Request for Proposal FY10-0226 for Construction of Storage Building

Addendum No.:   3   (herein referred to as "Addendum")

STORAGE BUILDING FOR NEESES

5 DETAIL  
A1-3 | A1-3 SCALE: 1" = 1'-0"

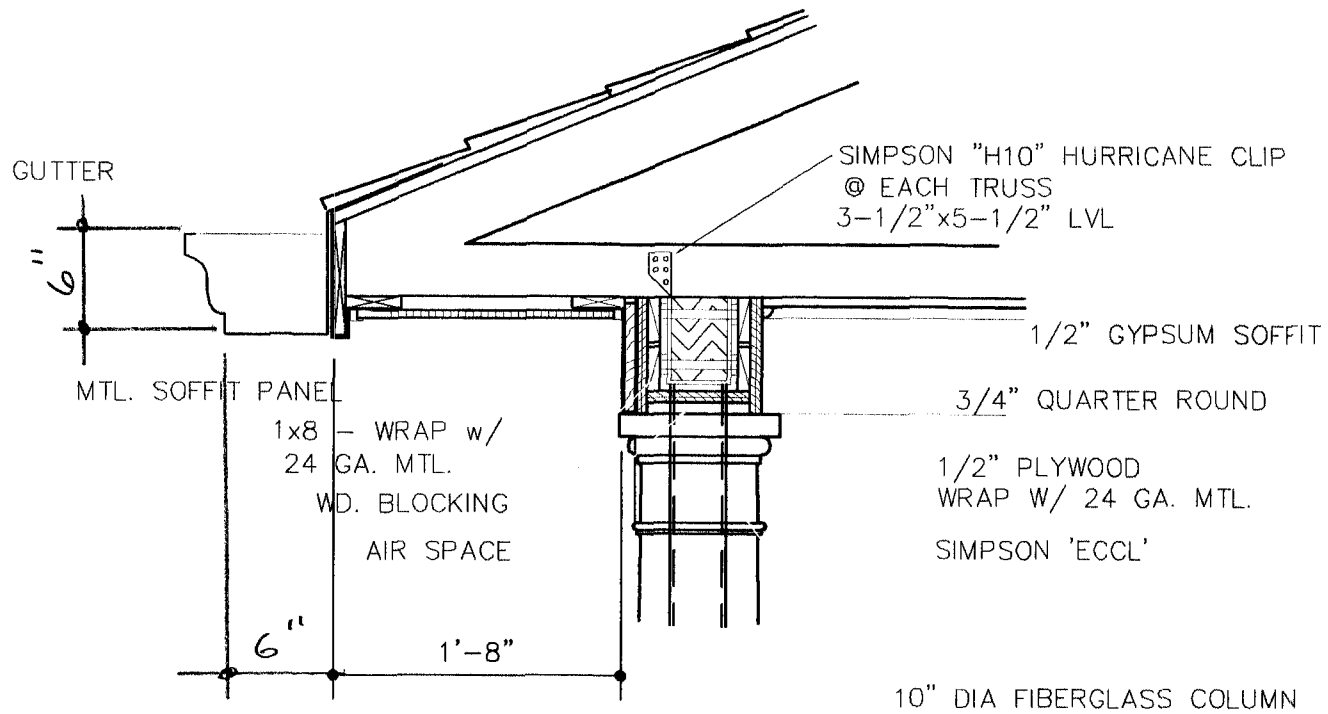
7. 1 X 8 sub-facia is used to match existing Town Hall.
8. See attached drawing for gutter dimensions.
9. Material for wrapping frieze board may be 26 gauge,
